SECTION V

Boards

AM-420 Power Cycle Modification

ISSG Newsletter

AM-420 Component Side

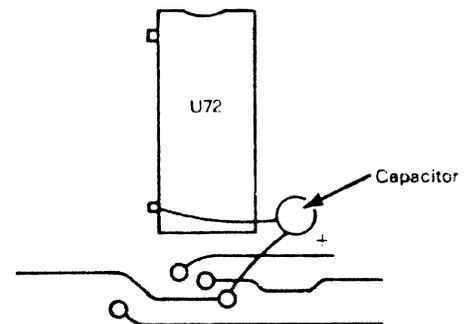
1. On the component side of the AM-420 circuit board, cut the etch between U34 pin 7 and the pad. (See below.)

2. Add a 2.2 microfarad capacitor (CPP-00225-01) between U72, pin 10 and the pad as shown below.

AM-420 Component Side

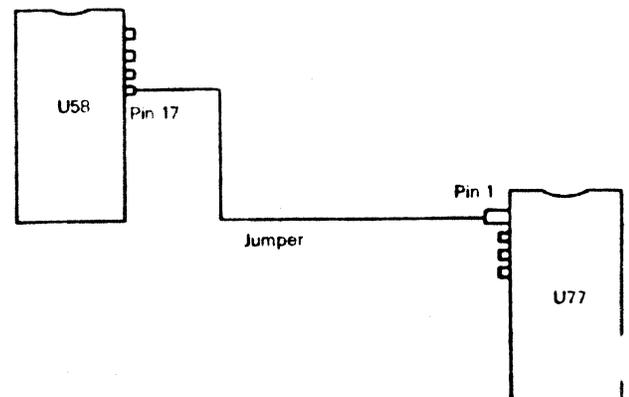
The "+" side is in the pad. Be sure to install sleeving on both leads of the capacitor.

Schematic Changes

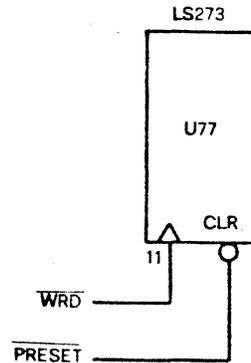
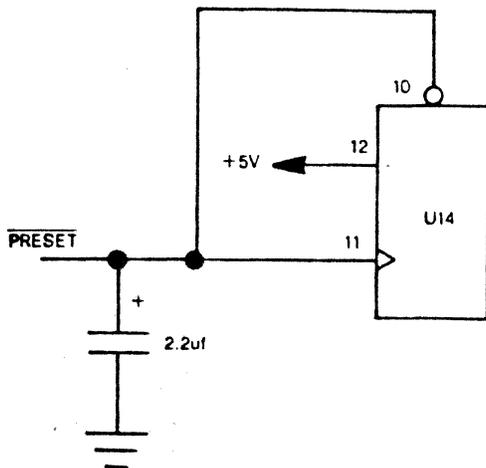
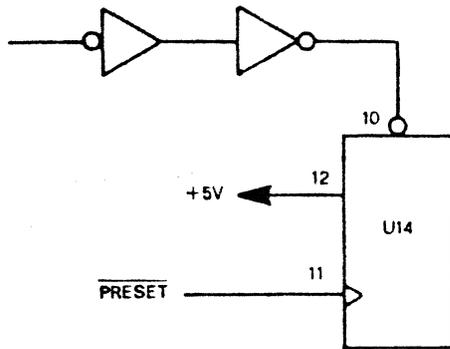
Sheet 4, B6

Make the following changes to DWL-00420-XX.

Sheet 1, A7

Sheet 2D8

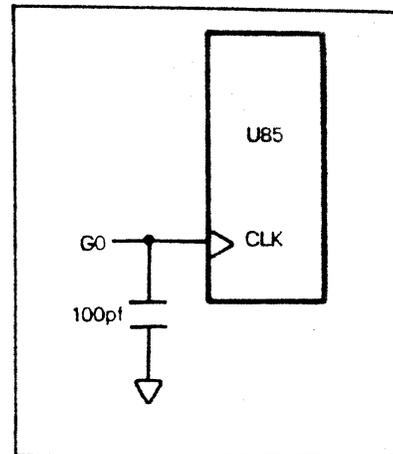
Make the following changes to DWL-00420-00.

Sheet 4A1

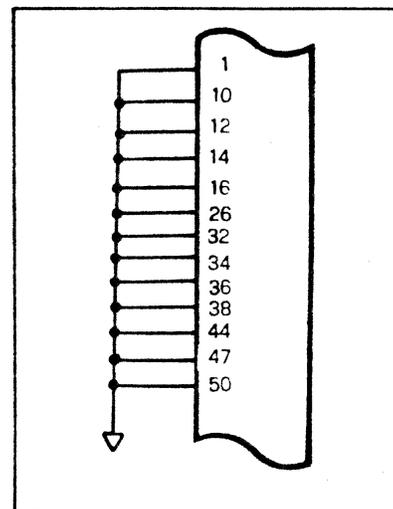
ADD

Sheet 2D4
WAS

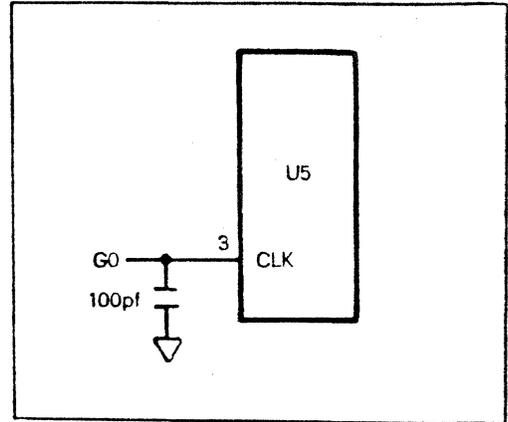
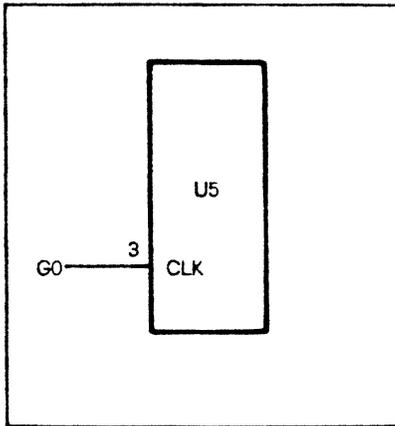
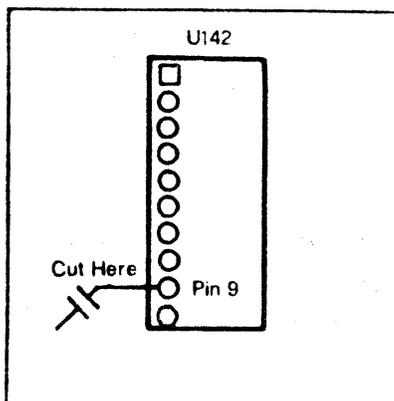
Make the following changes to DWL-00420-XX.

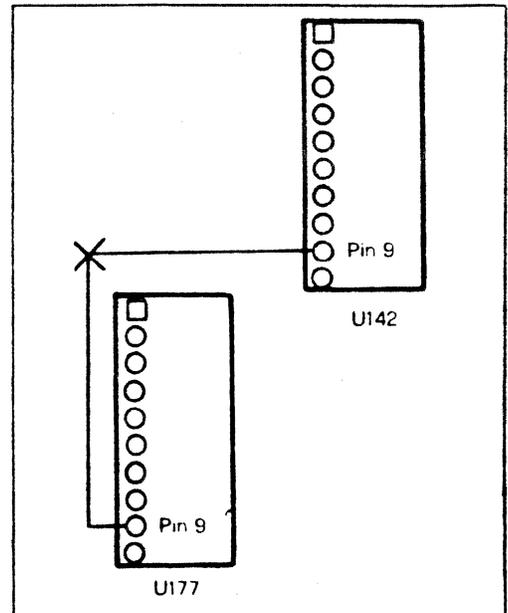
1. Locate integrated circuit chip U142. U142 is oriented toward the front and left on the main logic board in the system.
2. Cut the trace going to pin 9 of U142. Pin 9 is on the left hand side of U142 as you face the front panel of the AM-1000.
3. Locate the trace that runs from pin 9 of U142 toward the left.

CAUTION: Be sure to cut only the one trace and do not accidentally cut surrounding traces.

4. Add a jumper to the circuit board, originating from U142, pin 9, to integrated circuit chip U177, pin 9.

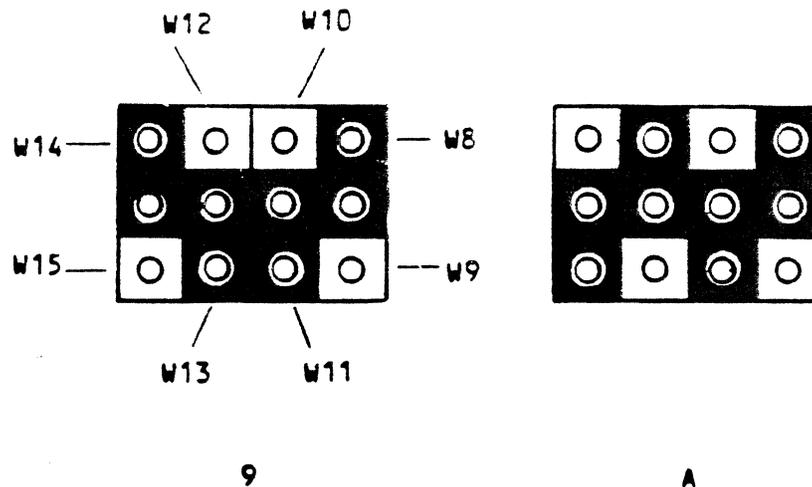
Figure 1 shows the location of the boot jumpers on the AM-1000 CPU circuit board and the jumper configuration required for different boot devices. Notice that Boot Device ID code 9 is the only configuration identifying the VCR. Assuming that the system contains a Winchester disk as the primary booting device, all that needs to be done to bypass the VCR delay is to reconfigure the boot jumpers to Boot Device ID code A (Floppy/Winch).

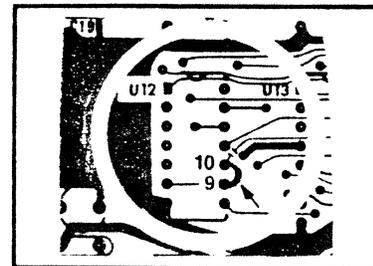
1. Locate U-12.
2. Cut an etch at U-12, pin 10.
3. Jumper U-12, pin 9 to U-12, pin 10.

IS	WAS
DWB-00420-99	CO4	C03

Make the following changes to DWL-00420-XX schematic, Sheet 2, Zone 5C:

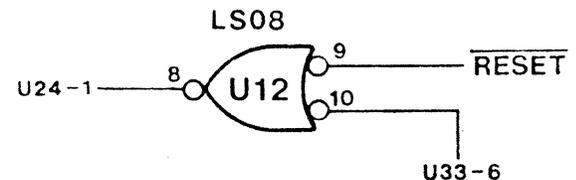
Was:

Is:

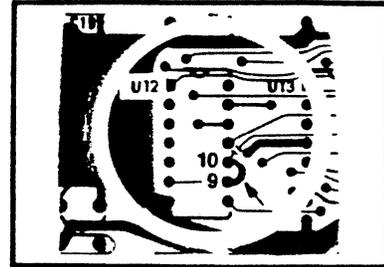
1. Locate U-12.
2. Cut an etch at U-12, pin 10.
3. Jumper U-12, pin 9 to U-12, pin 10.

IS	WAS
DWB-00420-99	C04	C03

Make the following changes to DWL-00420-XX schematic, Sheet 2, Zone 5C:

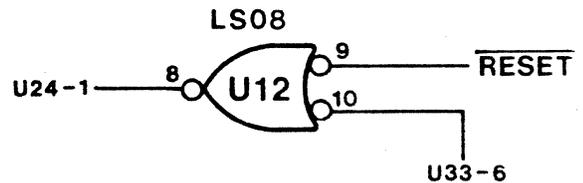
Was:

Is:

FIGURE 1 AM-300 BOARD

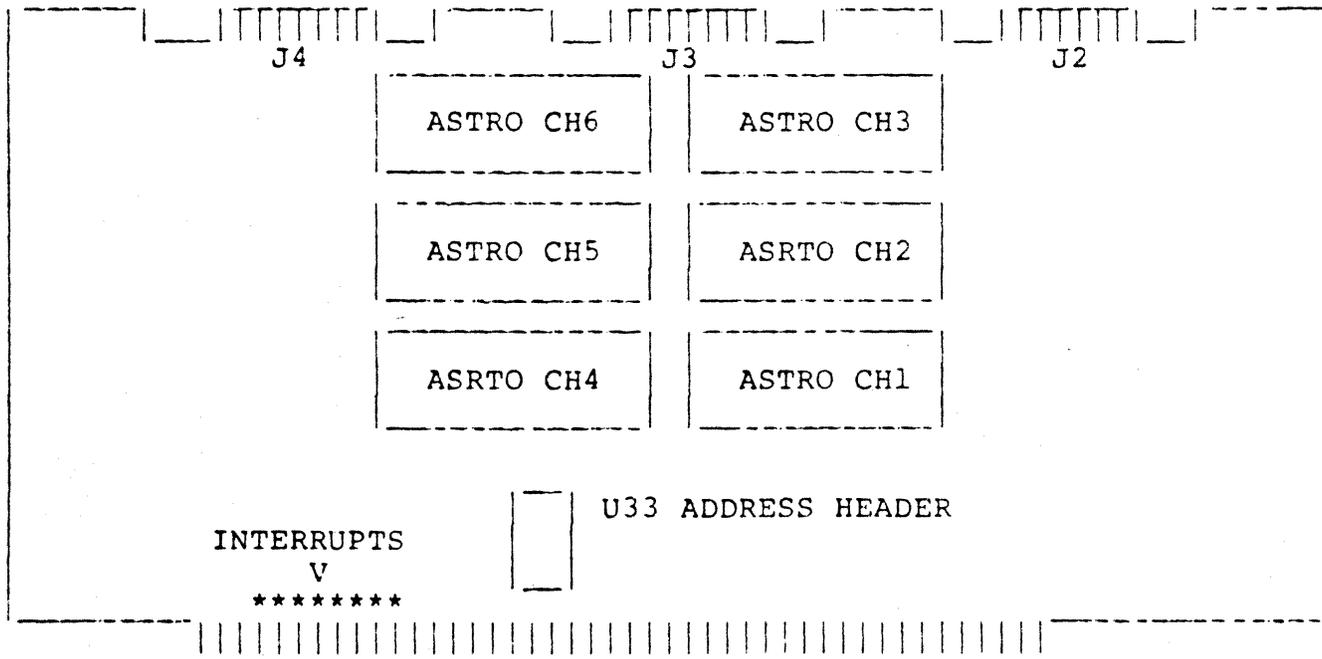
As an example, a second AM-300 board will be set up using I/O address E8 and interrupt level 6. See Figure 1 below. On the AM-300 board, find the ADDRESS HEADER and the INTERRUPT lines.

FIGURE 2
ADDRESS HEADER

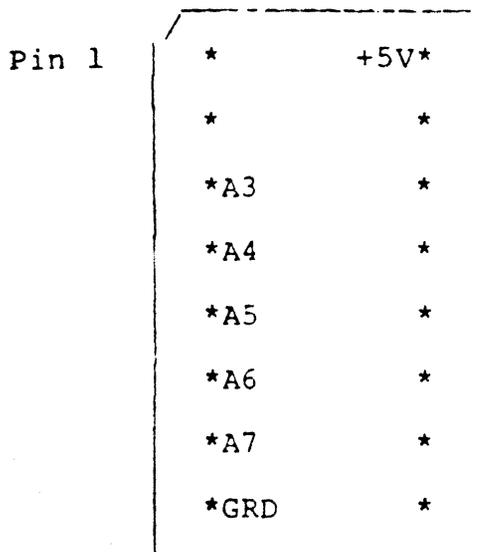
The address header is normally set up for address F8. This header will be changed to E8. Figure 2 shows the address header and the pin identification. Pins 3 thru 7 are the address lines A3 thru A7. Pin 16 is + 5 volts and pin 8 is ground. The address lines are tied to +5 volts to make the address lines "1" level or to ground for a "0" level.

An address of E8 will have A3,A5,A6 and A7 jumpered to +5 volts and A4 jumpered to ground.

FIGURE 3 AM-300 BOARD (Lower left corner)

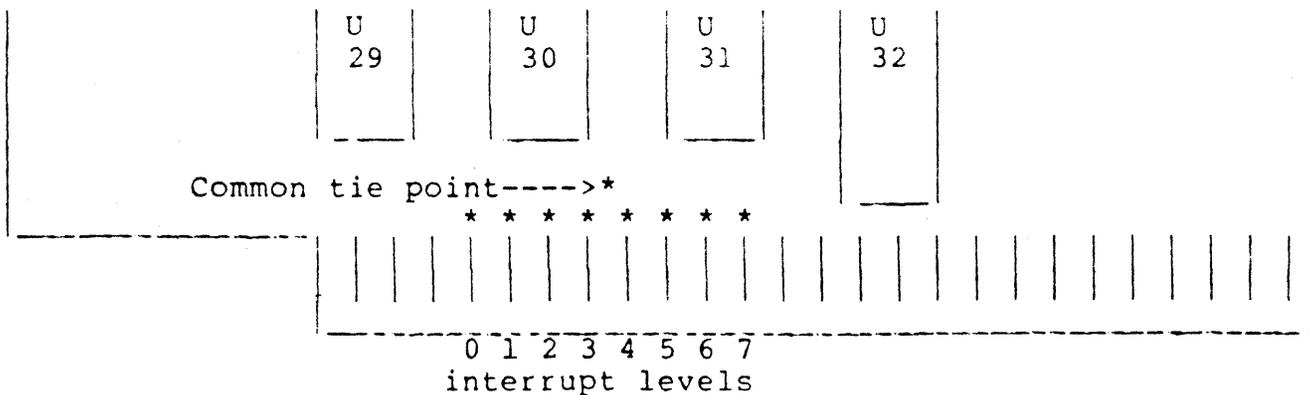
After the address has been changed to E8, the interrupt level must be changed to "6" for this example. See Figure 3 for interrupt identification.

To change the interrupt, level the jumper (foil etch on older boards) must be installed from the common tie point to the correct interrupt pad. In this example to the pad labeled "VI 6".
